## Accessibility Survey

### City of Downey Raebert Street - Vultee Avenue to Corrigan Avenue

Vultee Avenue to Corrigan Avenue  
Downey, CA 90242

Date of Inspection  
8/7/2017

**Change in Level East of Vultee Avenue @ 33.928304473694, -118.126760870218**

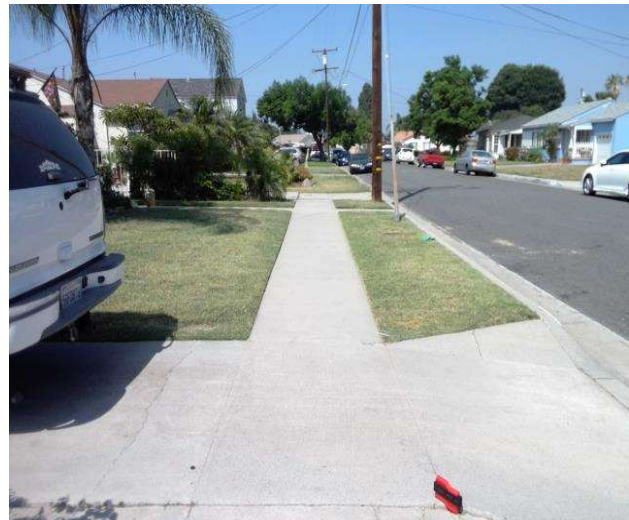
Sidewalks , Change in Level : Change in Level Non Beveled

There is a change in elevation greater than recommended value.

**On-Site Finding** 0.62 inches

Ensure that the change in elevation is within the recommended value.

Recommendation Up to 0.25 inches
